DUANE ARNOLD ENERGY CENTER

AMENDMENT TO FACILITY OPERATING LICENSE

SAFETY EVALUATION BY THE OFFICE OF NUCLEAR REACTOR REGULATION

SUPPORTING AMENDMENT NO. 47 TO LICENSE NO. DPR-49

Figure 2

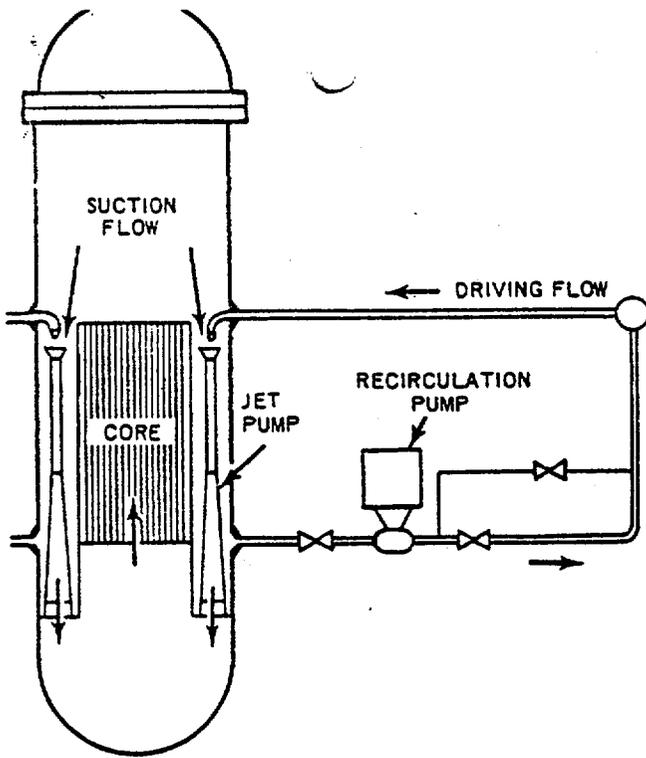
The new safe-end design removes the thermal sleeve attachment weld from the primary pressure boundary and eliminates the sharp crevice in the high residual tensile stress area. In the new design, the thermal sleeve is welded to the safe-end at a point away from the pressure boundary wall (see Weld #3, Figure 2). The new safe-end design improves the in-service inspection access at the nozzle attachment end by maintaining longer straight inside and outside surfaces, thus simplifying ultrasonic angle beam examinations.

The installation of the new assemblies involves five separate welds at each safe-end (see Figure 2). Prior to installation, each weld was mocked up to demonstrate reproducibility of welding and dimensional control of weld shrinkage. Because the root of the production weld between the thermal sleeve and the safe-end could not be examined after welding to confirm that complete fusion was achieved, the mockup weld was sectioned, etched and examined. Although it was observed that the backing ring deformed against the thermal sleeve creating a crevice-like condition, the joint is not located on the primary pressure boundary of the safe-end, therefore if the condition were to induce IGSCC the pressure boundary integrity would be unaffected.

Recirculation System Elevation
 and Isometric

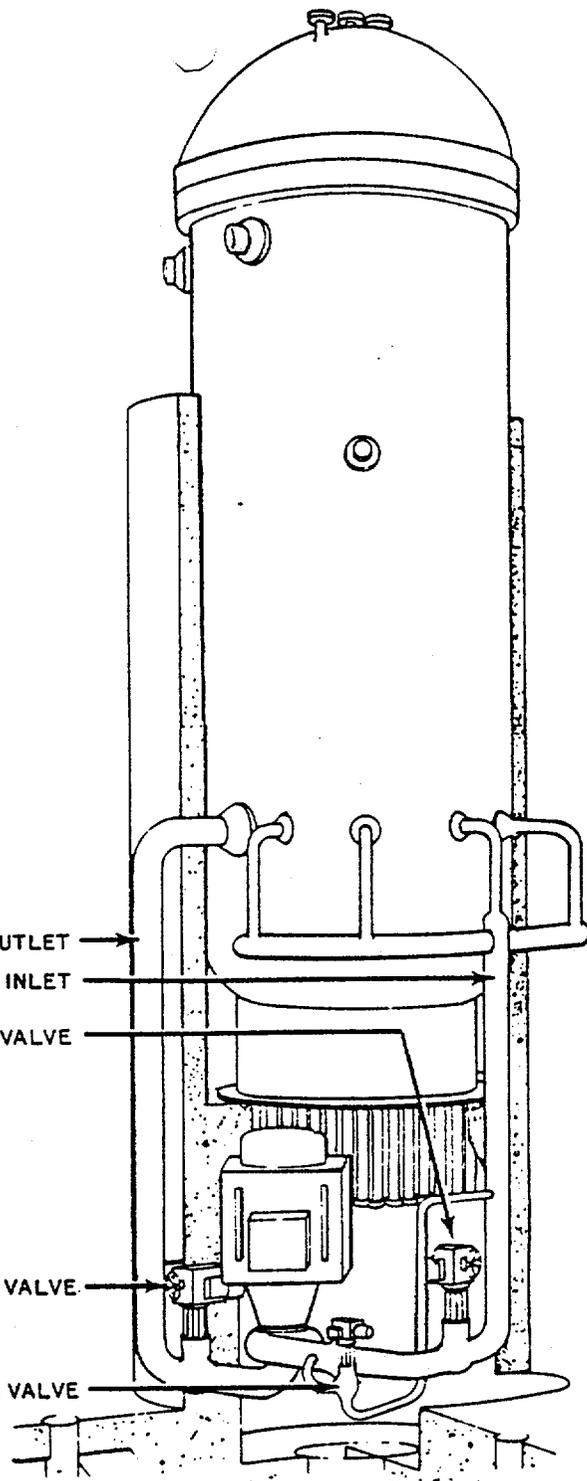
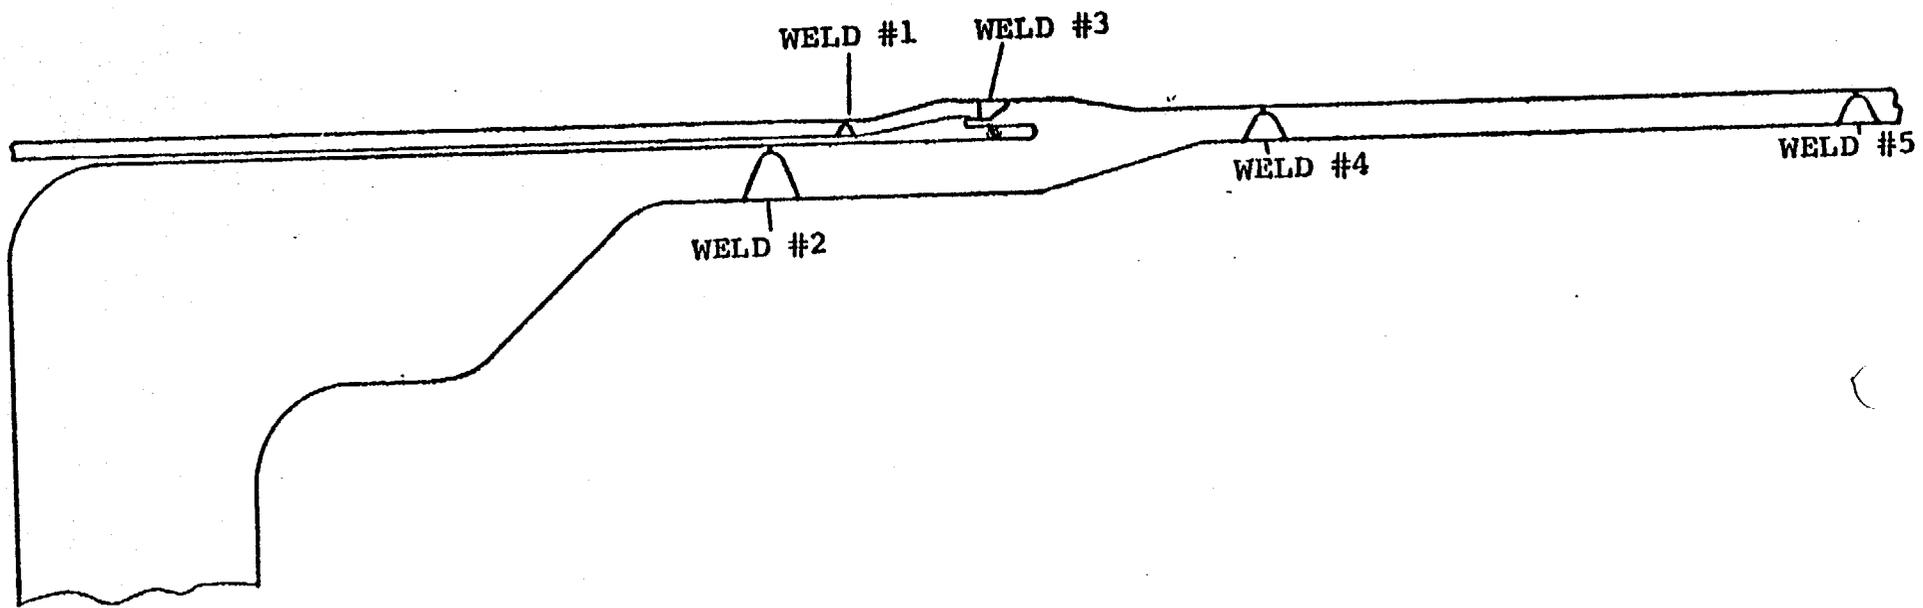
The modification consists of replacing the existing eight cracked recirculation inlet nozzle safe-ends with redesigned safe-ends and thermal sleeve adapters. The safe-ends were fabricated from SB-166 (Alloy 600) material.** They function as transition pieces between the stainless steel reactor recirculation piping and the carbon steel reactor vessel nozzles, and as attachment points for the internal thermal sleeves, that carry the recirculation flow to the jet pump risers (see Figure 1).
